Chestnut Ridge/Arden Courts of Germantown: Preliminary Plan No. 120170210

Chestnut Ridge/Arden Courts, Preliminary Plan No. 120170210:

Recommendation – Approval with conditions

Figure 3 - Preliminary Plan

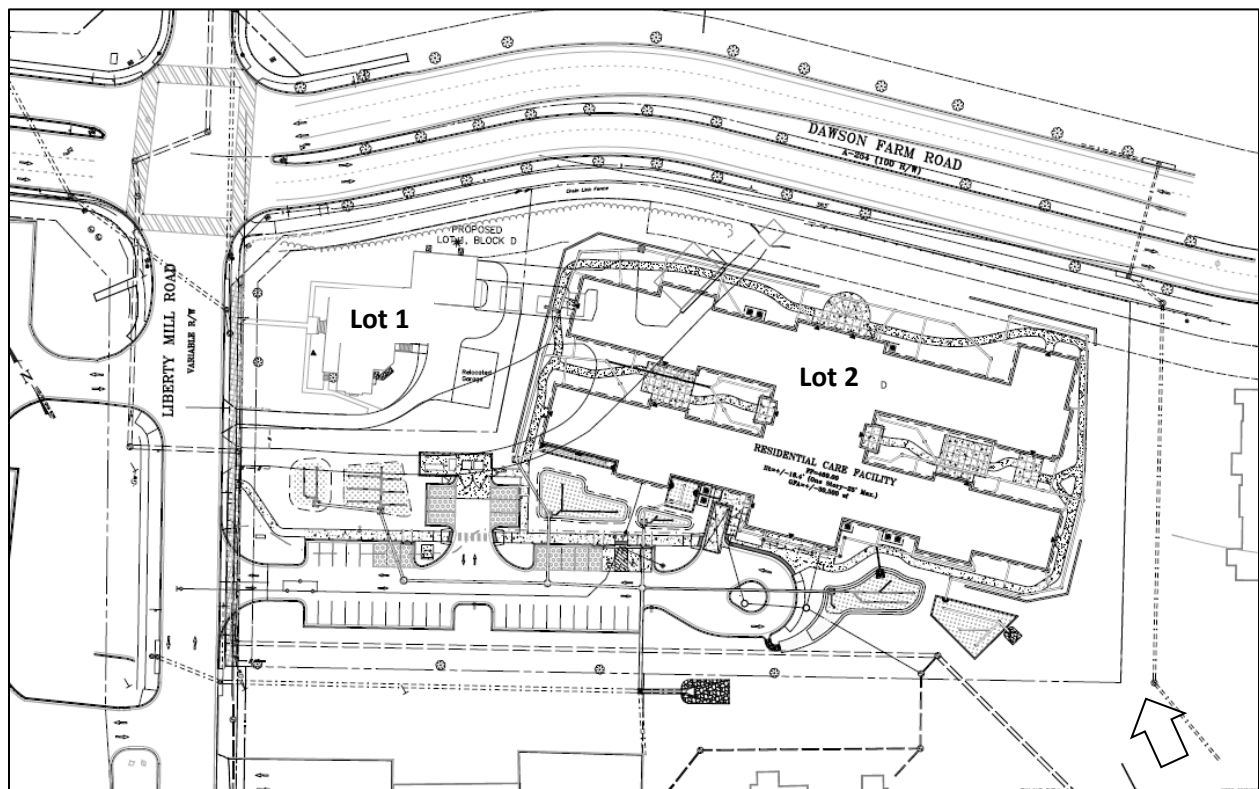
Lot 1 will comprise approximately 23,283 square feet (0.53 acres) and will include the existing single-family home and a detached garage. The existing northernmost access off Liberty Mill Road will serve the lot.

Lot 2 will consist of approximately 134,674 square-feet (3.09 acres) and will include a 31,000 square-foot residential care facility with a total of 64 beds and a total of 44 parking spaces for staff and visitors. The
